**HISTORIC PRESERVATION REVIEW BOARD
STAFF REPORT AND RECOMMENDATION**

Landmark/District:	Grant Road Historic District	<input checked="" type="checkbox"/> Agenda
Address:	4543 Grant Road NW	<input type="checkbox"/> Consent
Meeting Date:	September 22, 2016	<input checked="" type="checkbox"/> Alterations
Case Number:	16-621	<input checked="" type="checkbox"/> Addition
		<input checked="" type="checkbox"/> Demolition
Staff Reviewer:	Tim Dennée	<input checked="" type="checkbox"/> Concept

A detail of the 1927 Sanborn atlas depicting the house as it then stood, and lacking a garage immediately behind.

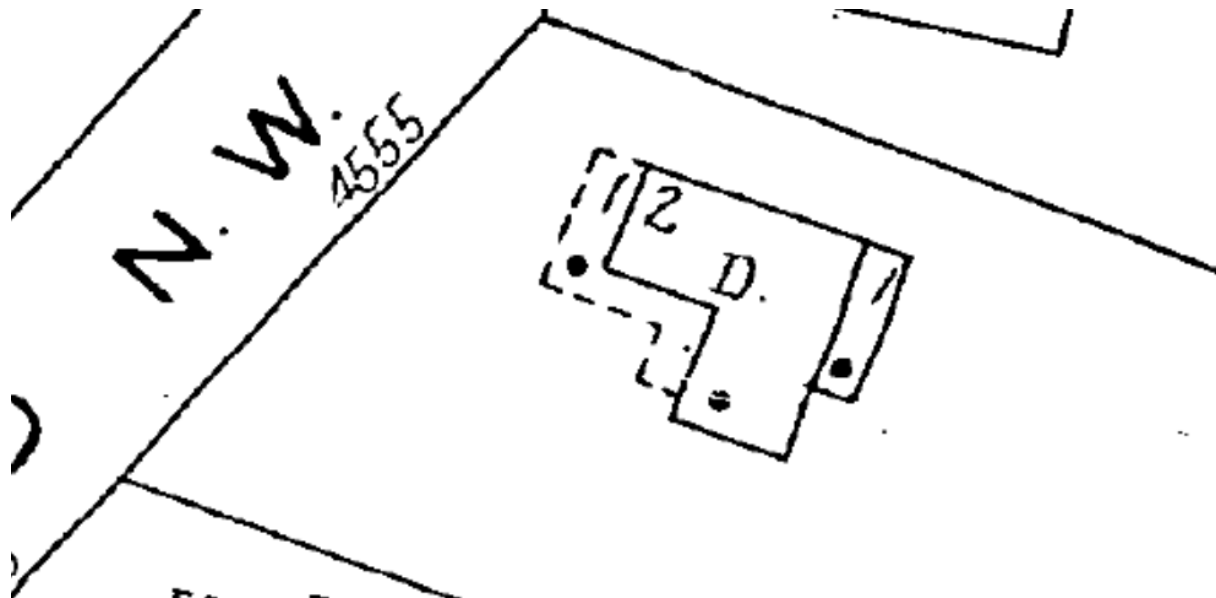
As it is to be removed to make way for the rear addition and storage structure, the first question is whether the demolition of the garage is consistent with the purposes of the preservation law. The nomination makes mention of only a single garage (at 4426 Grant Road) and long-demolished stables within the historic district, without identifying any extant accessory structures as contributing to the character of the district. The house that became 4543 once had its own stable or sheds at the very rear of the property, constructed in 1913-1914 and probably demolished when 38th Street began to be subdivided. The present garage was built in 1942, postdating the historic district's period of significance.
